**MEETING AGENDA
SESSION OF THE PLANNING ADVISORY BOARD
CITY OF KISSIMMEE
CITY HALL, COMMISSION CHAMBERS
101 CHURCH STREET, KISSIMMEE, FLORIDA 34741-5054
WEDNESDAY, MARCH 19, 2025 AT 6:00 PM**

Public Hearing - Conditional Use with Site Plan to establish a drive-thru restaurant and retail establishments – 4307 W Vine St - CU-24-0014

**ADDRESS: 4307 W VINE ST
PERMIT NUMBER: CU-24-0014
PROJECT NAME: 4307 W VINE ST REDEVELOPMENT
REVIEW VERSION NUMBER: V.2**

DATE: 02/18/2025
PROJECT NO.:
DRAWN BY: JAC
CHECKED BY: JAC
SCALE: 1" = 20'
SHEET: C-5.0

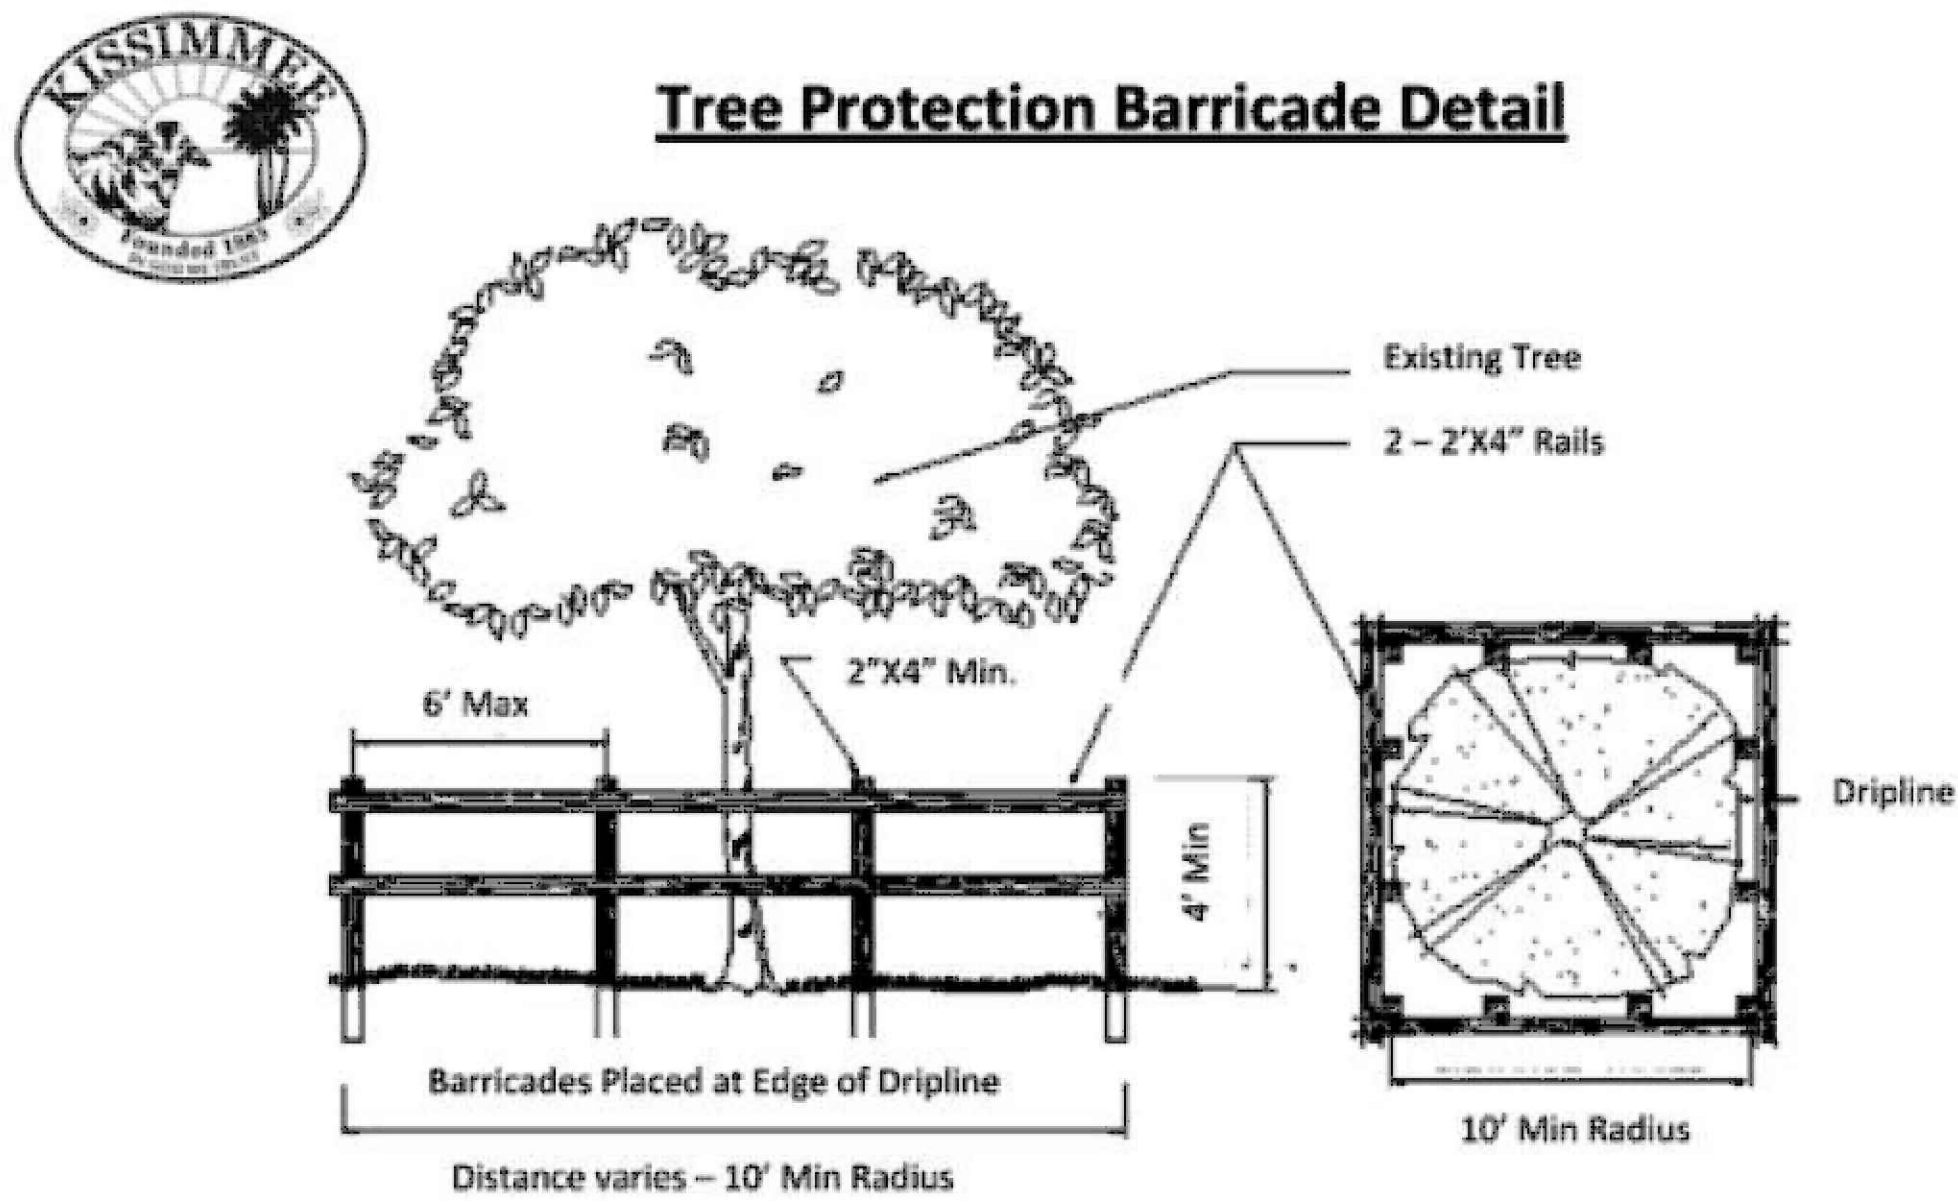
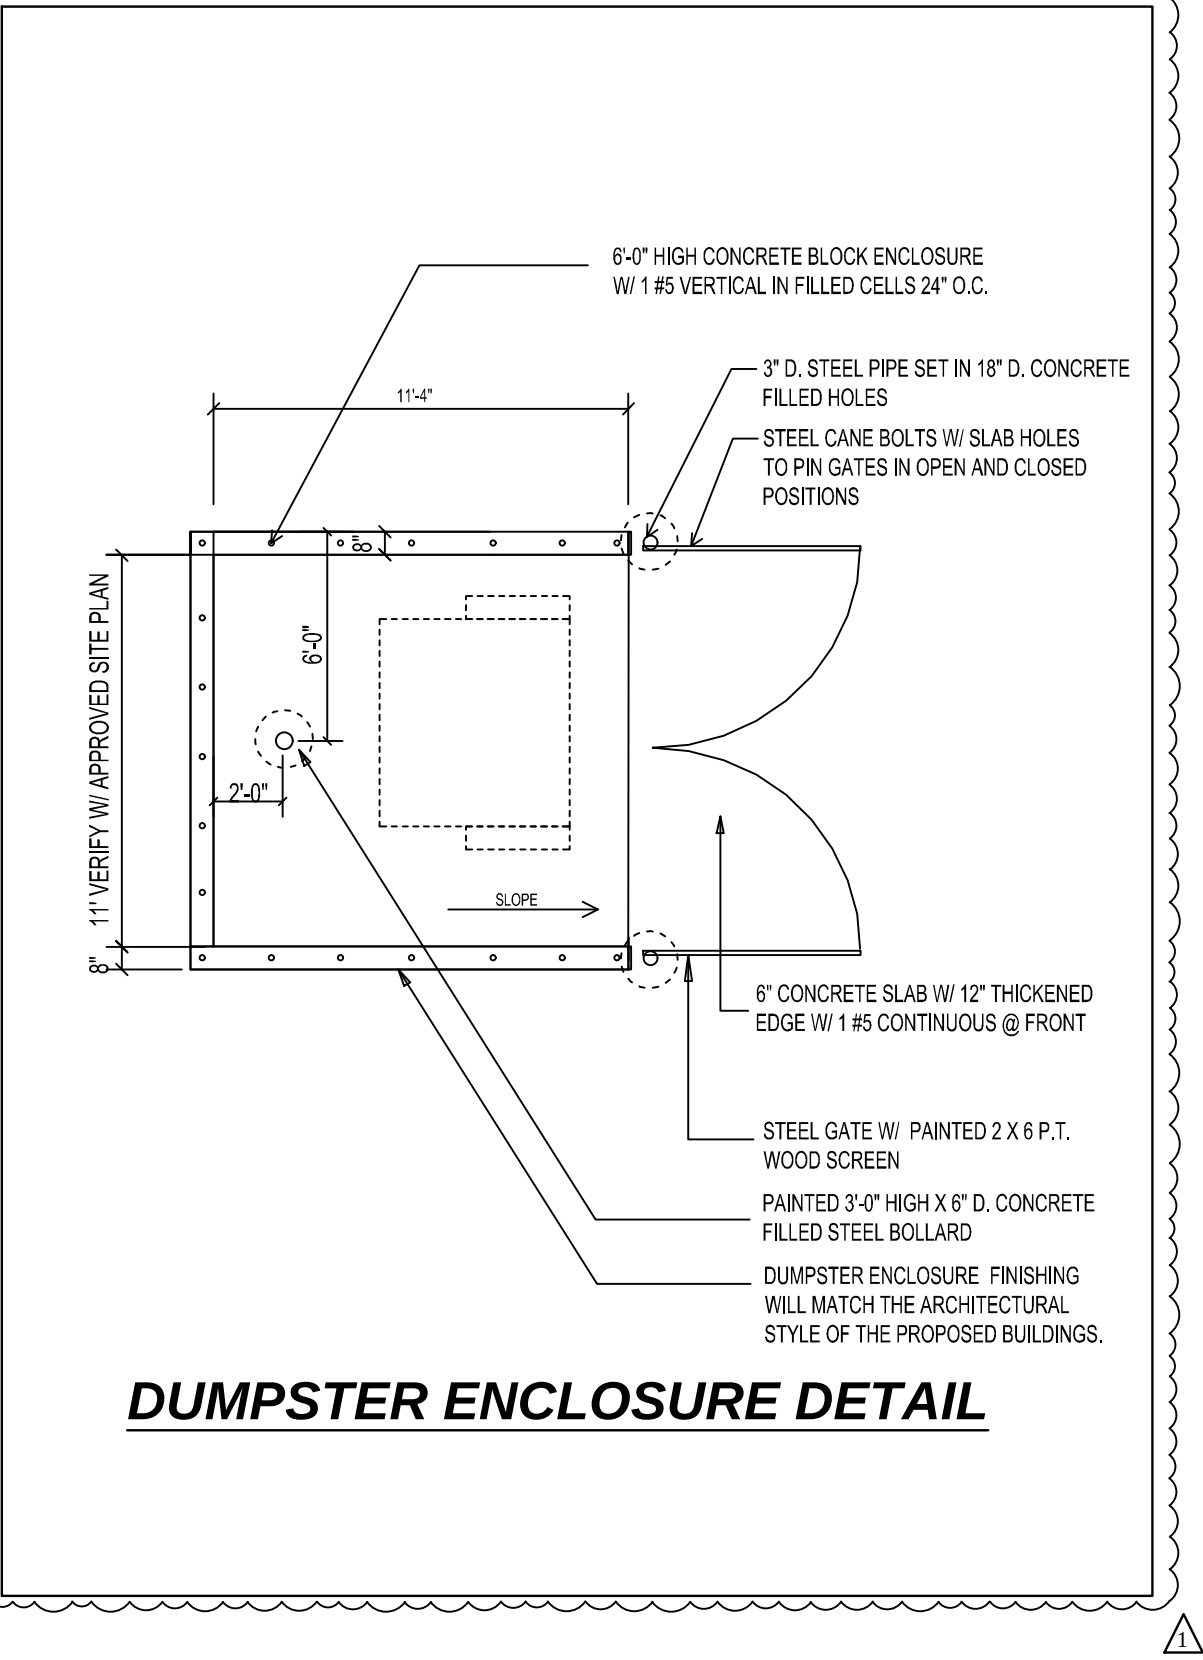
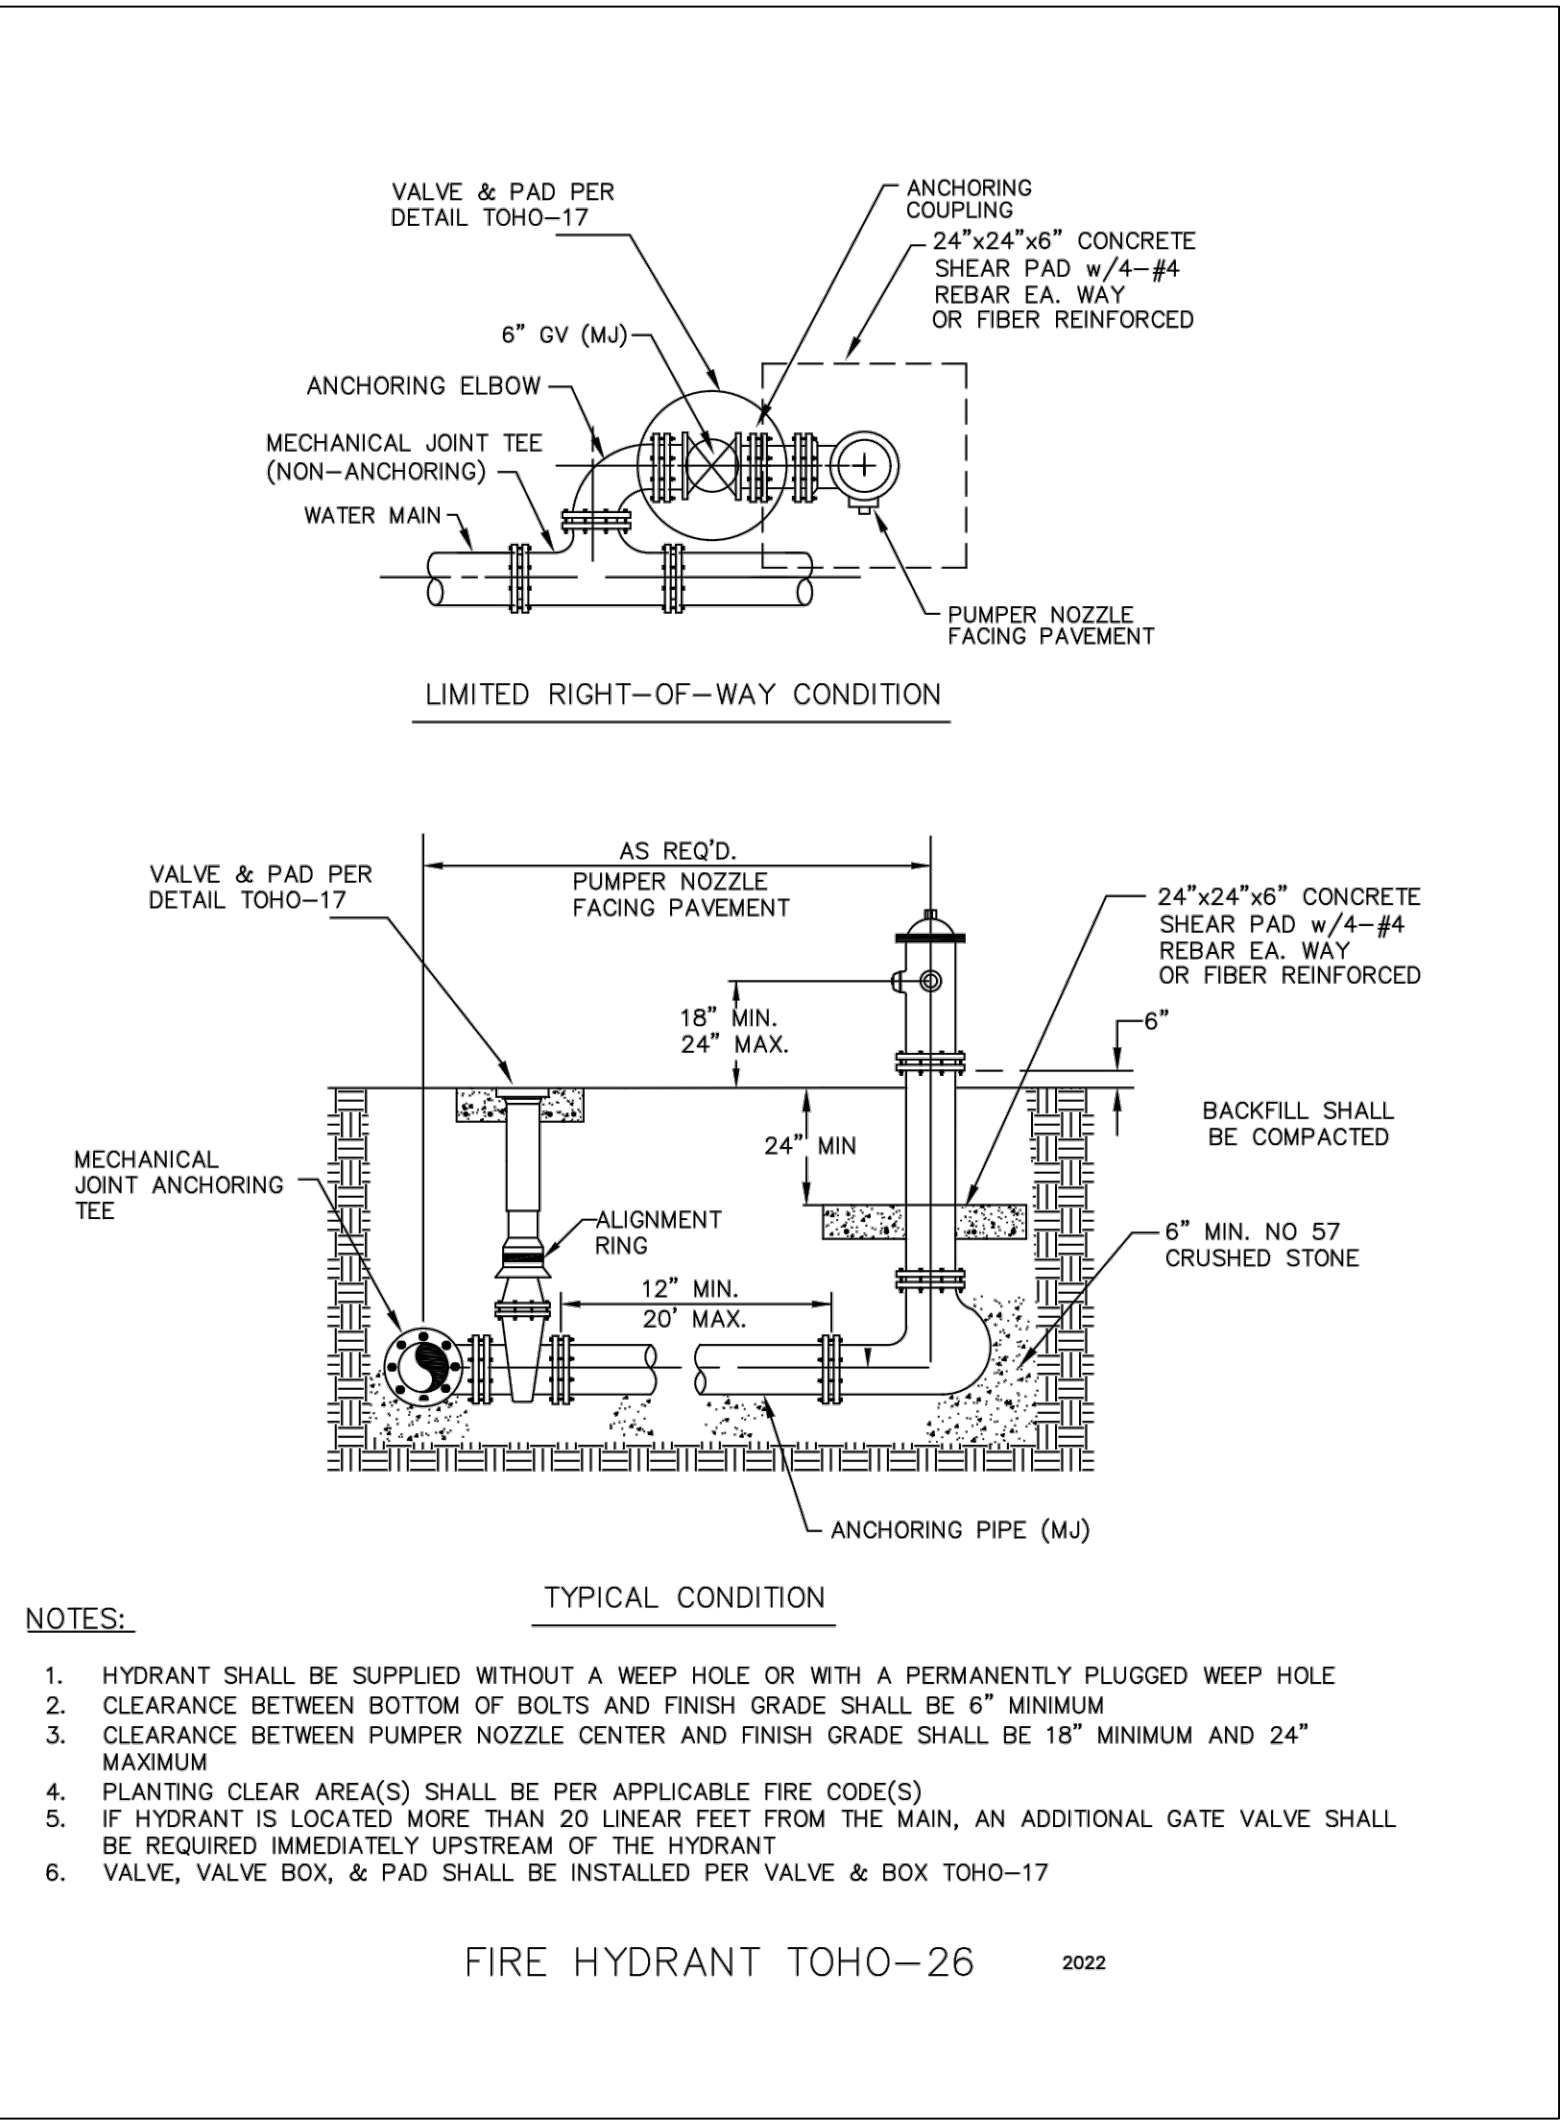
4. Please add proposed spot elevations on the SSRP's Preliminary Grading and Drainage Plan sheet.
5. Please review LDC Section 14-5-7 D 3, forecourt standards regarding courtyard regulations in the form-based zoning code. Ensure that the courtyard area on the SSRP matches that within the Elevations and Floor Plan set.

Response: Preliminary spot elevations have been included on the SSRP's Preliminary Grading and Drainage Plan sheet
